APPLICATION NO.	FILING DATE	FIRST NAMED INVENTOR	ATTORNEY DOCKET NO.	CONFIRMATION NO.
10/779,700	02/18/2004	Lin I-Yung	OP-092000407	8957

Office Action Summary

DETAILED ACTION

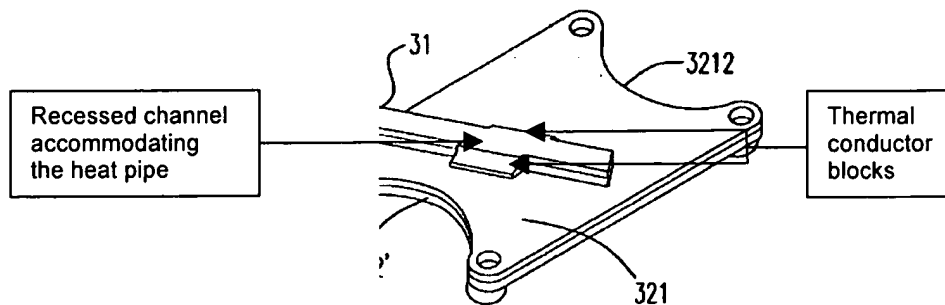
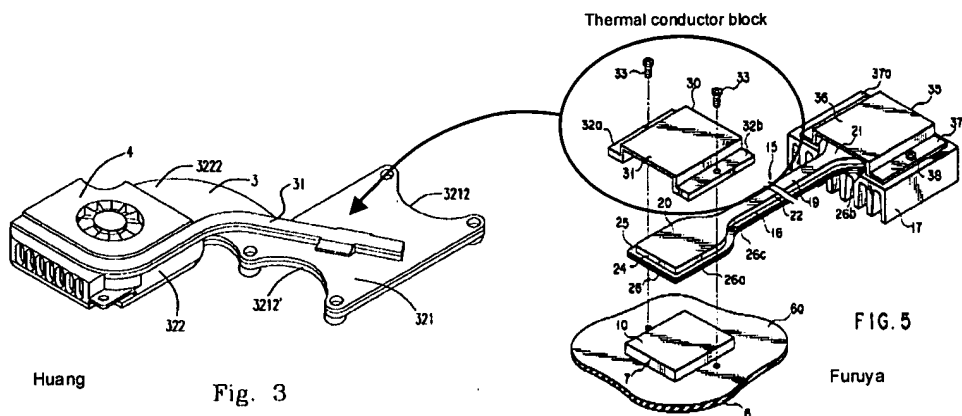
- Regarding claim 1, Huang discloses a heat dissipation structure, comprising: a heat sink (3), installed on a heat generating electronic device (1); at least one heat pipe (31), having a proximal end located on the heat sink and a distal end extends outside of the heat sink, wherein the heat pipe includes a wick structure and a working fluid therein (a heat pipe by definition is a heat transfer device with a sealed metal tube having an inner lining of wick like material and a small amount of liquid. See, for example, the definition of heat pipe in *McGraw-Hill Dictionary of Scientific and Technical Terms, Sixth edition*); a set of fins connected to the distal end of the heat pipe (marked in figure); at least one thermal conductor block installed on the heat sink and adjacent to the heat pipe (marked in figure), the thermal conductor block is operative to store thermal energy.

- Regarding claim 2, Huang further discloses that the heat sink further comprises an extension towards the set of fins (see figure).
- Regarding claim 3, Huang further discloses that the extension extends over the set of fins to form a guide portion.

- Regarding claim 4, Huang further discloses that the electronic device included a central processing unit (marked '1', paragraph 0020).

- Regarding claim 5, Huang further discloses two thermal conductor blocks at two sides of the heat pipe.
- Regarding claim 6, Huang further discloses that the thermal conductor includes a recessed channel for accommodating the heat pipe therein (see figure).
- Regarding claim 11, Huang further discloses that the thermal conductor block is fabricated in a form of reinforcing rib.
